# Tronox LLC Henderson Facility Fact Sheet

Re: **Tronox LLC (TRX)**  
**NDEP Facility ID #H-000539**  
Nevada Division of Environmental Protection (NDEP) Response to:  
*Appendix E -Data Validation Summary Report (DVSR) Annual Remedial Performance Report for Chromium and Perchlorate*  
Dated December 18, 2008

**PHASE B SOURCE AREA INVESTIGATION  
REVISIONS TO AREA I THROUGH IV WORK PLANS  
DRAFT TEXT/Drawing SUBMITTAL – NOVEMBER 10, 2008**

SHEET NUMBER	1
FIGURE NUMBER	1

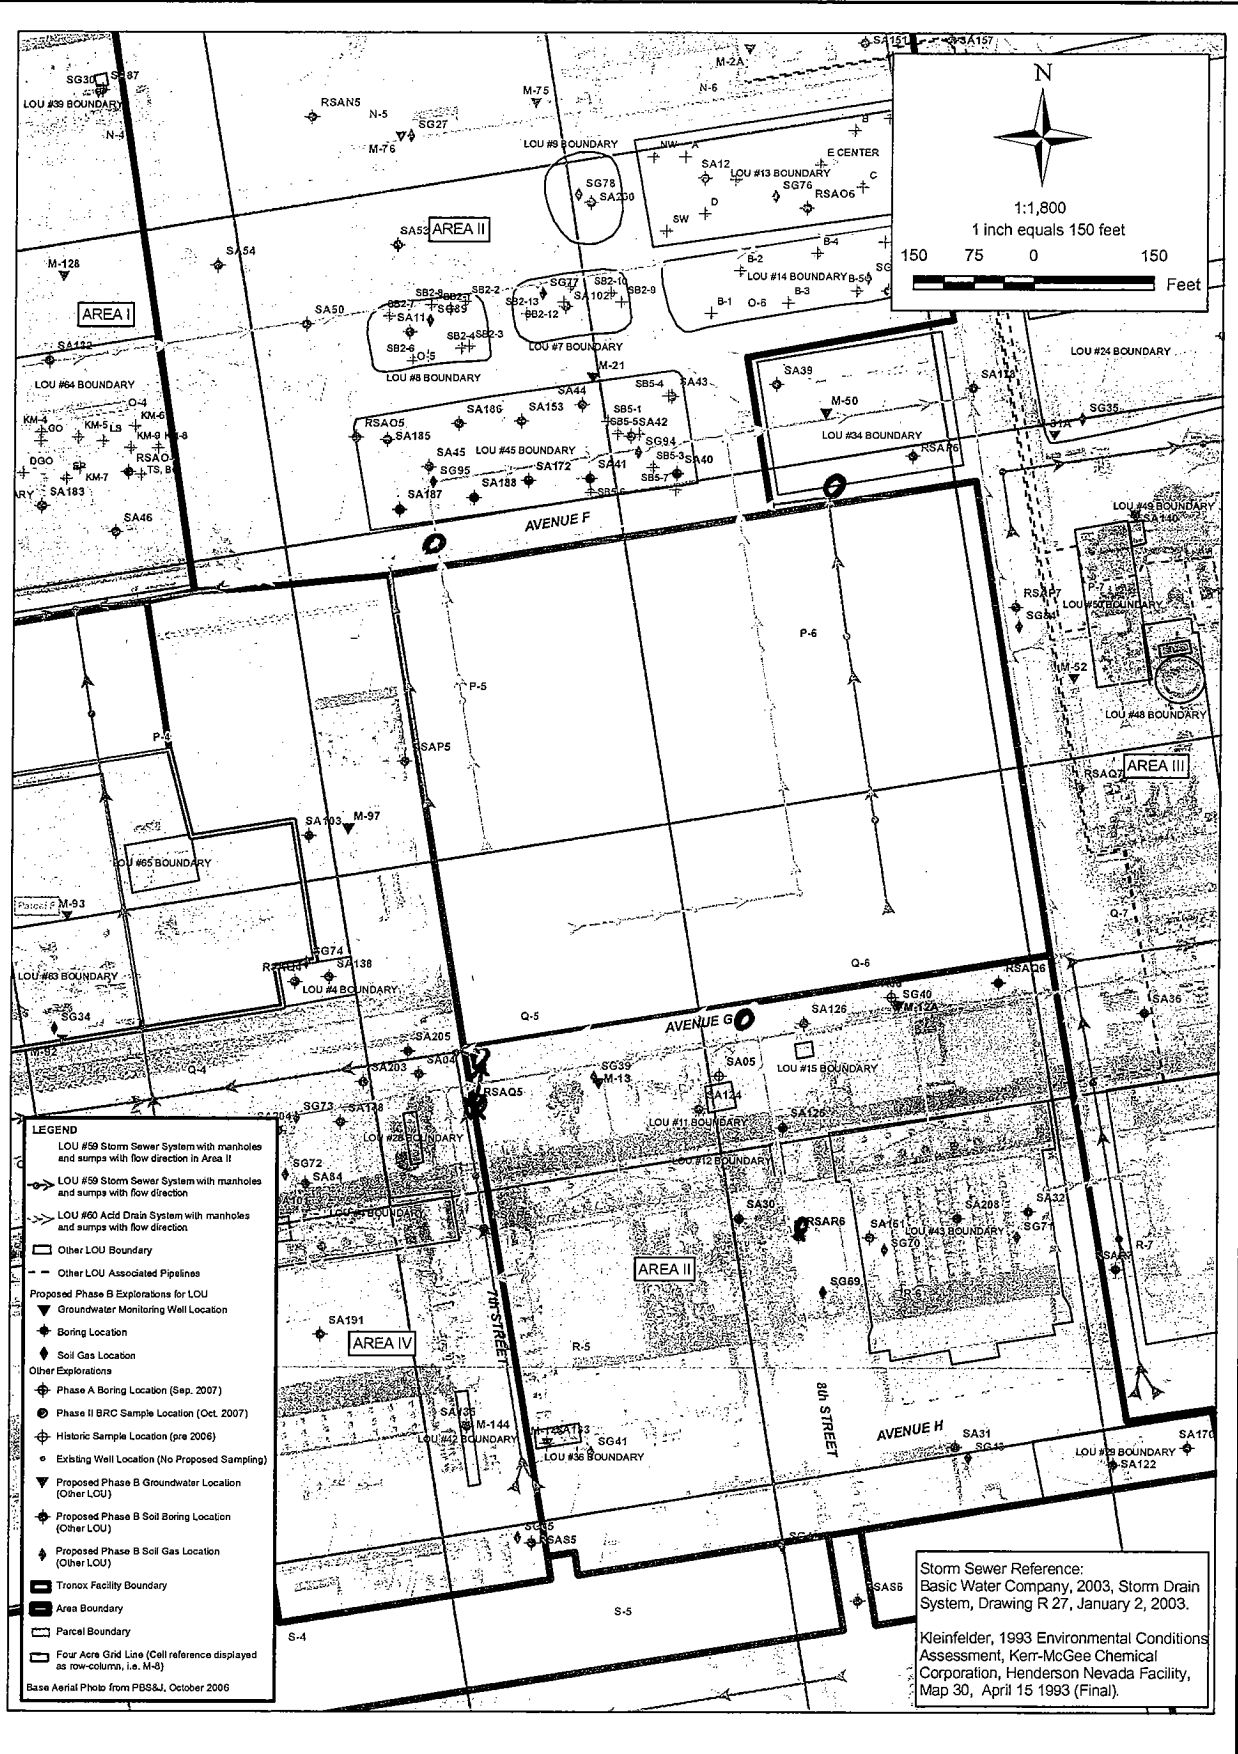
additional boring  
 additional boring  
 additional boring  
 North of ChemStar, south of Lou 45, over Lou 60  
 North of ChemStar, south of Lou 39, at 90° turn  
 South of ChemStar, at 90° turn  
 adjacent to Lou 59  
 move R5 & B6 over Lou 60
